PENRITH CITY COUNCIL

MAJOR ASSESSMENT REPORT

Application number:	DA20/0644
Proposed development:	Demolition of Existing Structures & Construction of 200 Place Child Care Centre including Related Car Parking, Fencing, Tree Removal, Landscaping & Drainage & Site Works
Property address:	15 - 17 Garswood Road, GLENMORE PARK NSW 2745
Property description:	Lot 4211 DP 1150762
Date received:	7 October 2020
Assessing officer	Lauren Van Etten
Zoning:	SEPP WSA - Affected by Obstacle Limitation SEPP WSA - Affected by Wildlife Buffer Zone E4 Environmental Living - LEP 2010
Class of building:	Class 9b
Recommendations:	Refuse

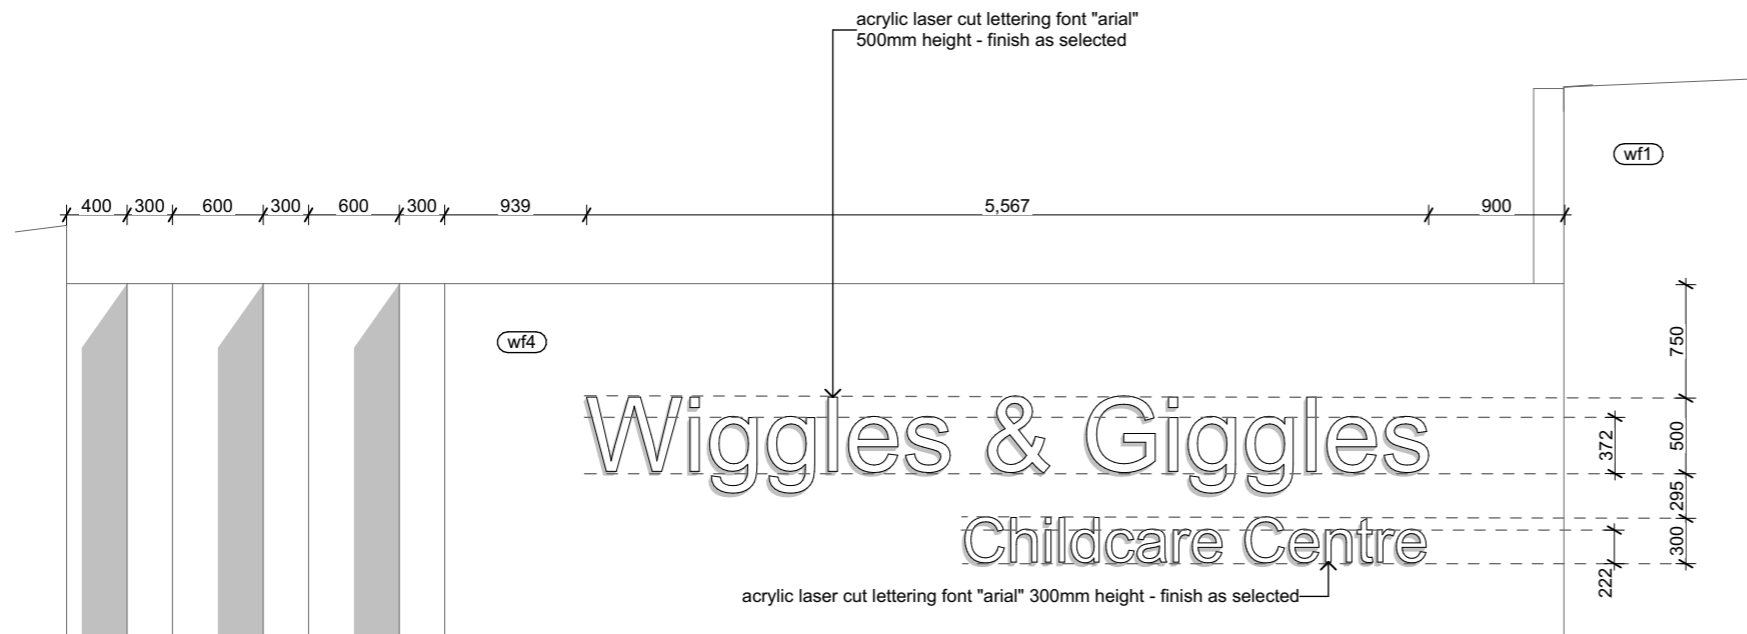
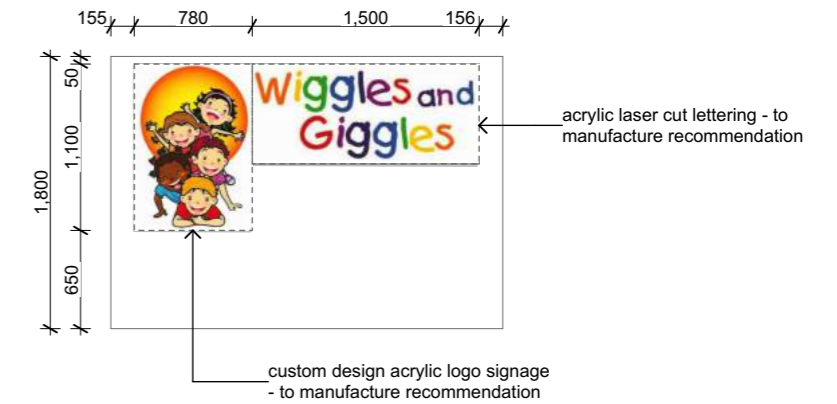
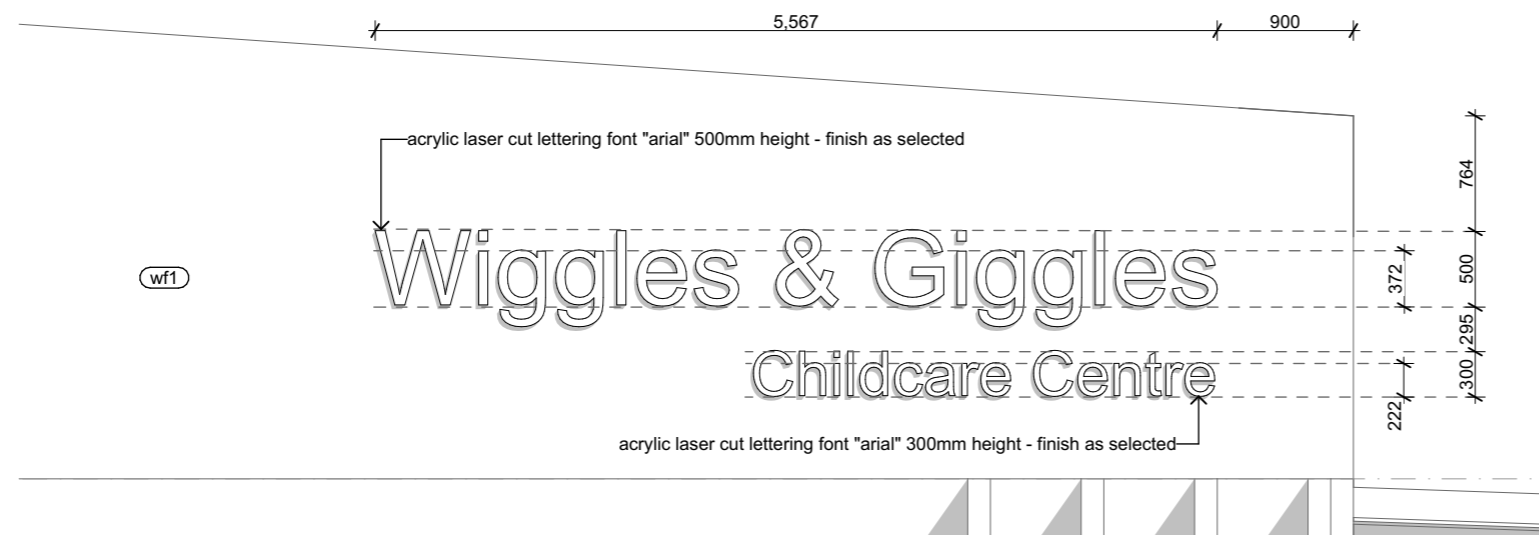
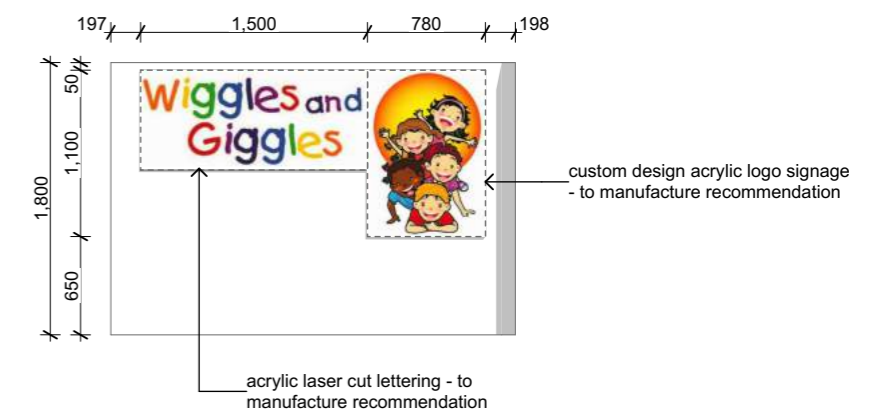
The number of proposed signs is incompatible in the rural-residential context. A revised signage plan could remove the excessive signs i.e. the wall signs and ensure only one sign is proposed on the façade to integrate with the area's rural landscape character. However, as detailed elsewhere within this report, there are reasons for refusal for this application.
